# Staff Report

## Tentative Partition Plat

RL-02-24

July 16, 2024

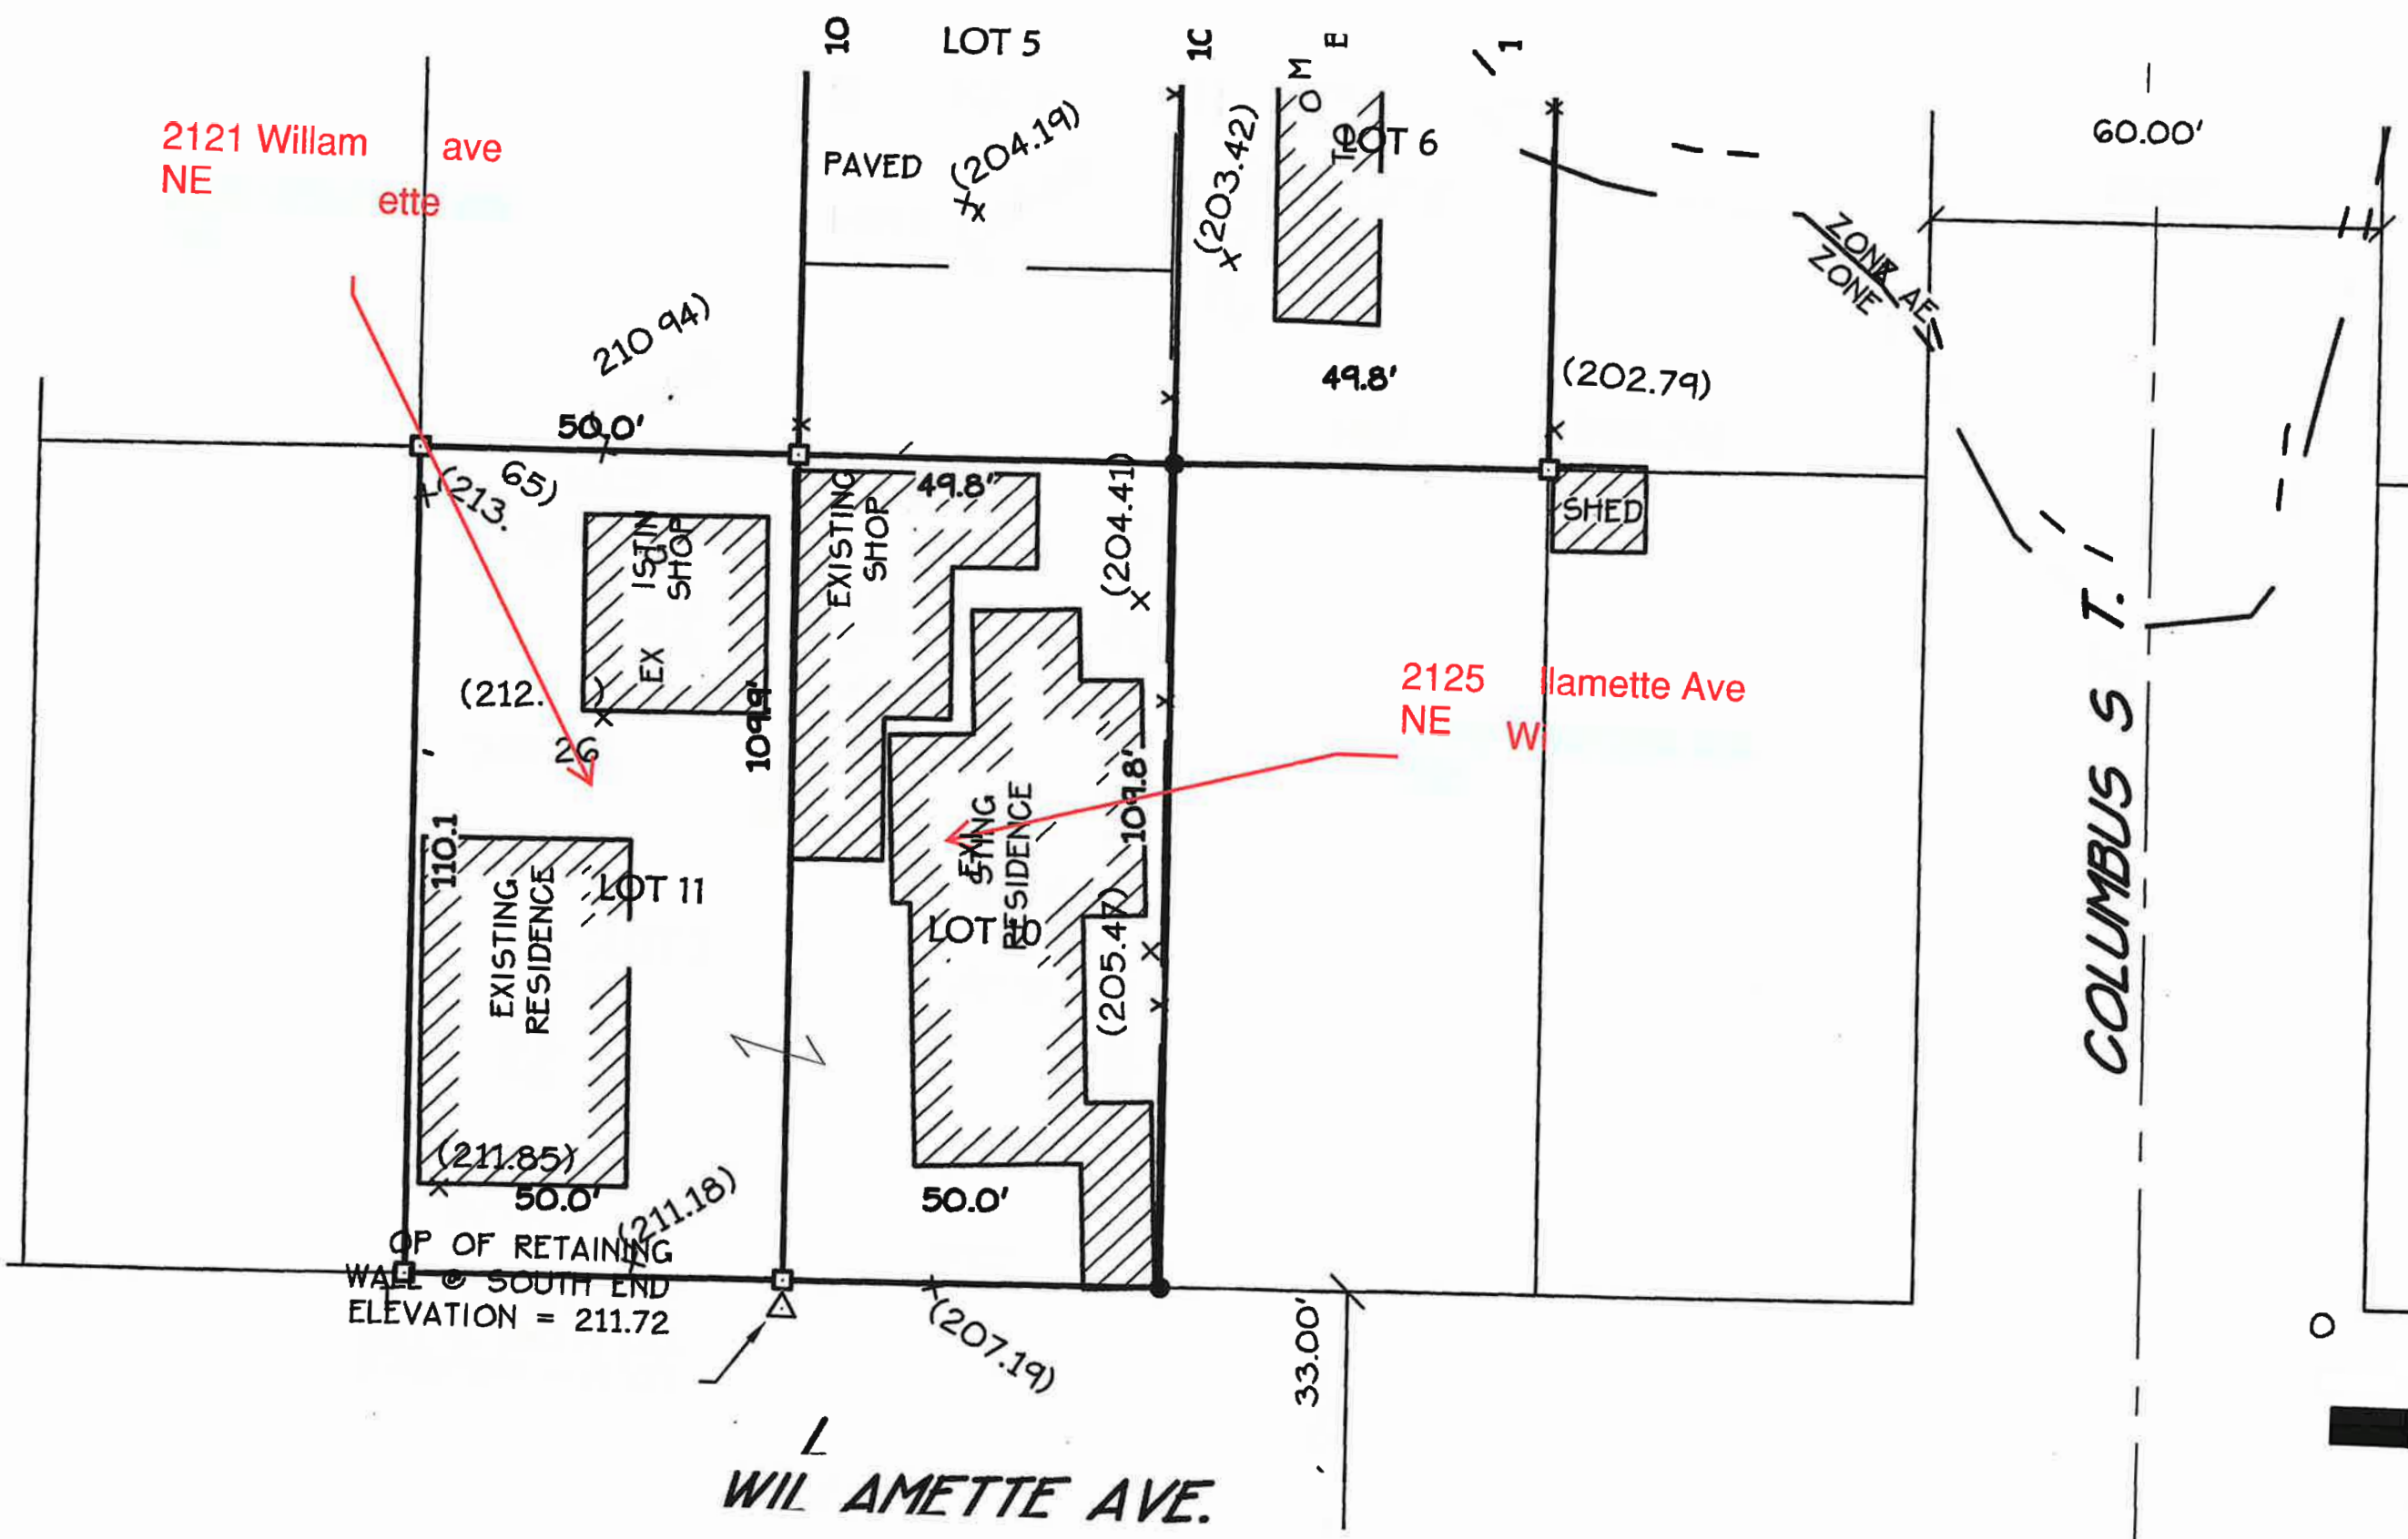
- 1.1 The applicant proposes to consolidate two lots into one unit of land. The applicant has applied for a demolition permit for each of the existing dwelling units. Upon consolidation of the lots the applicant proposes to develop a dwelling and an accessory dwelling unit.

- 1.2 The subject properties include Lots 10 and 11 of the Burkhart Park Addition Subdivision. The subject properties are identified on Linn County Assessor Map No. 11S-03W-05CA Tax Lots 6401 and 6403 (Attachment A). The sites have been assigned addresses of 2121 and 2125 Willamette Avenue NE.

- 1.10 ADC 11.090(4) states side yards of lots shall run at right angles to the street the property faces. The proposed property line will result in side yards that will run at right angles to the street frontage. This standard is met.
